Picture from INC showing the unused flow line near the separator.

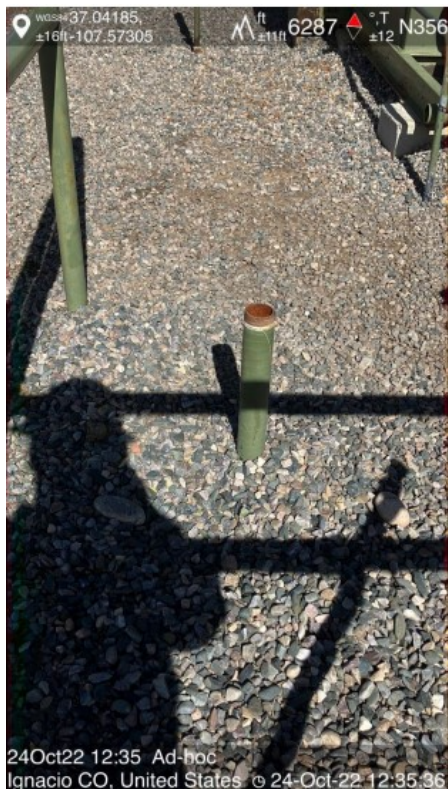
: 3" and 4" line from #2 3 wellhead to separator, 2 3" lines from C #1 to separator, 4" produced water line from separator to off location, 2 1" gas supply lines at separators. 2" line at C #1 separator is not in use and not locked out (IMG 05).

Corrective Action: Apply Out of Service Locked and Tagged on unused flow line per rule 1101.a(3) **Date: 10/27/2022**

Installed valve on unused flow line and locked and tagged out.
